## Additional Generalized Future Land Use Map Comments 6/8/18

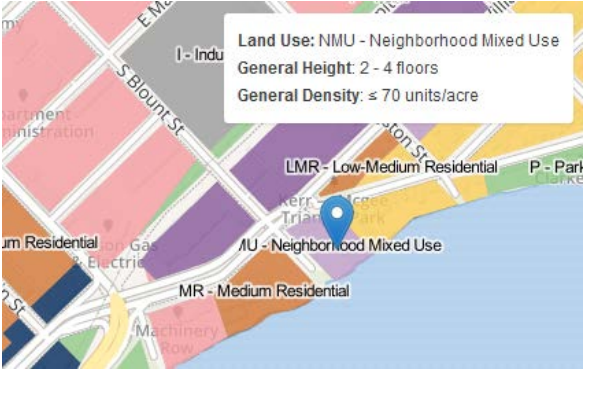
8	5/29 Krauskopf Message	Why was the Carey Ct. area changed from LR to LMR?	LMR is based on the current unit mix for the area (mix of single-family, duplex, and 3+ DUs). The message does not make a request to change the GFLU designation. See the discussion below for a location map and further analysis.	Maintain LMR.	N
9	5/29 sjkrausk Message (#1)	<p>Restrict buildings on the 2000 block of East Washington (on the N side) to two stories.</p> 	Staff interprets this as a request to change the area from LMR to LR. This area, along with the Options in Community Living apartments to the southwest and the E. Washington Ave. frontage to the northeast, were LDR in 2006. Staff reclassified the area with the addition of LMR as a category with this Plan update. The block bounded by Carey Ct., 2 <sup>nd</sup> St., E. Washington Ave., and 3 <sup>rd</sup> St., is made up of small-lot single family (generally 2,900-3,700 square foot lots), with three duplexes and one three-unit. This development is less intense than other LMR-designated areas to the southwest, southeast, and northeast, but the block is different than the exclusively single-family block to the northwest.	Maintain LMR.	Y

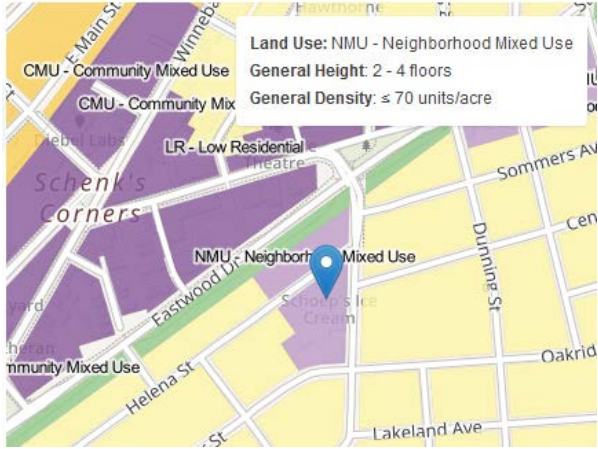
10	5/25 Dwyer & Lathrop Email	<p>Change Les Chateaux Apartments from MR to LMR to better match the Hoyt Park Neighborhood Plan designation of 16-25 DU/acre and 2-3 stories.</p> 	The Comprehensive Plan focuses on building form over density, and the building form and site layout of Les Chateaux Apartments, which has 128 units in 7 buildings on 8.5 acres, is more appropriate to the MR category. An LMR designation for this area, which is not along an arterial road, would be an indication that the type of building that currently exists is not appropriate for the area. This request is similar to the Marquette Neighborhood Association request to change the Fauerbach Condominiums from MR to LMR – while the parcel may meet the density range for LMR, the building form is not appropriate for LMR. MR is the best category for both existing and potential future redevelopment, which would still need to operate under the Neighborhood Plan.	Maintain MR designation.	N

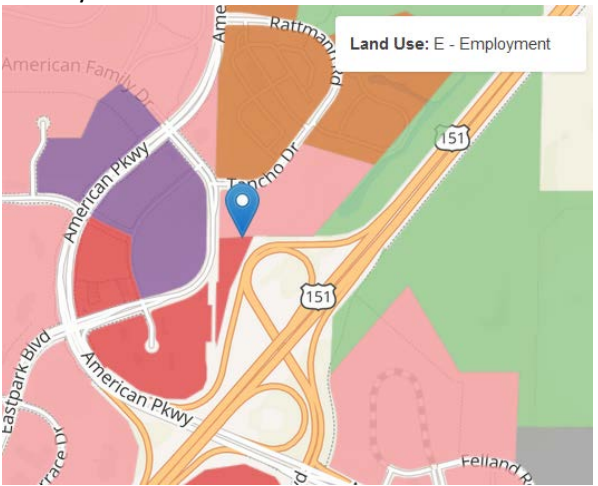
11	5/25 Dwyer & Lathrop Email	<p>Change parcels along Harvey St. between Schmidt Pl. and Hill St. from MR to LMR to better match the Hoyt Plan designation of 2-3 floors and 16-25 DU/ac.</p> 	<p>The area described at left is <b>not</b> specified for 16-25 DU/ac in the Hoyt Plan. In fact, the plan states that the area has “opportunity for higher density uses through lot assembly and redevelopment.” The area in question (area G on page 36 of the Hoyt plan) is specified to transition from taller buildings along University Avenue to a 2-3 story maximum along Harvey Street. 2-3 stories is within the MR range. The Comp Plan residential categories not only address height, but also building form. Staff feels that the building forms within the MR category are more appropriate for this area than the LMR category. The recommendations in the Neighborhood Plan as far as a 3 story height limit will remain.</p>	Maintain current MR designation.	N
